SERVICE INFORMATION

Number: 852-1729
Year: 1997
Month: FEBRUARY
Market: ALL

Rattling noise from passenger seat back (backrest)

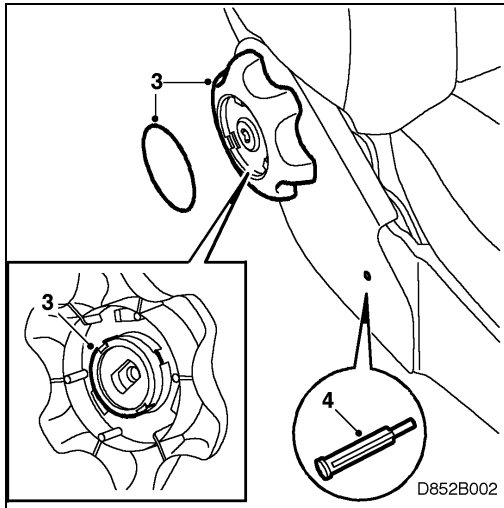
An irritating rattling noise from the passenger seat-back can occur in some cars. The rattle has been traced to clearance in the seat-back lock catches and the sleeves when there is no passenger in the seat.

If a customer complains about the rattling noise, the sleeves should be replaced with new sleeves of a different material.

Sleeve: 45 31 331

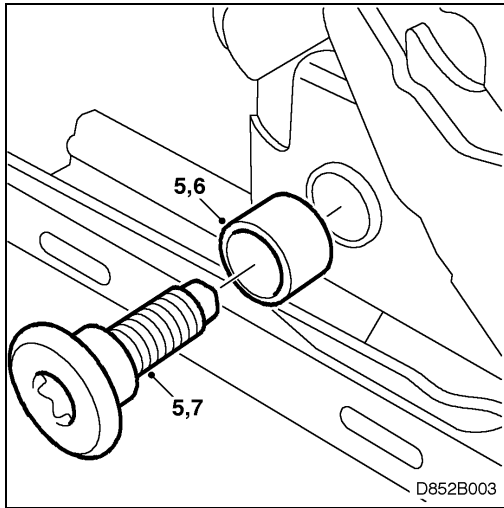
- 4 Press out the expansion pin in the cover between the seat-back adjusting mechanism and the seat frame, and carefully remove the cover.

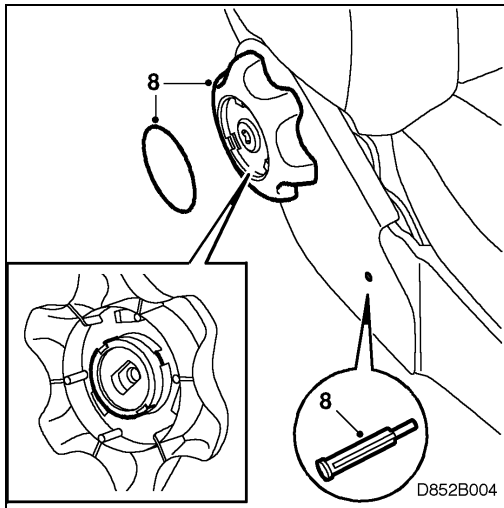
- 5 Fold the seat-back forward. Undo the screw (Torx 50) and remove the sleeve. Use pliers if the sleeve is stubborn.

- 6 Fit the new sleeve and check that it turns freely. If not, use a file to smooth the shank.

The screw must not be filed under any circumstances, as this can adversely affect its strength properties.

Tightening torque: 39 Nm (28.8 lbf ft)

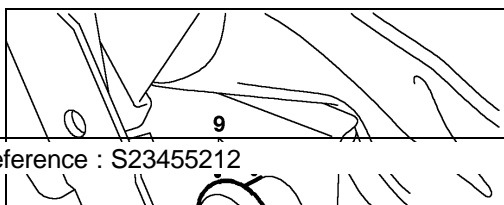
- 8 Fit the cover and the adjusting knob complete with plastic bush.

- 9 Continue on the other side of the seat. Undo the screw and remove the sleeve, using pliers if the sleeve proves stubborn.

Tightening torque: 39 Nm (28.8 lbf ft)
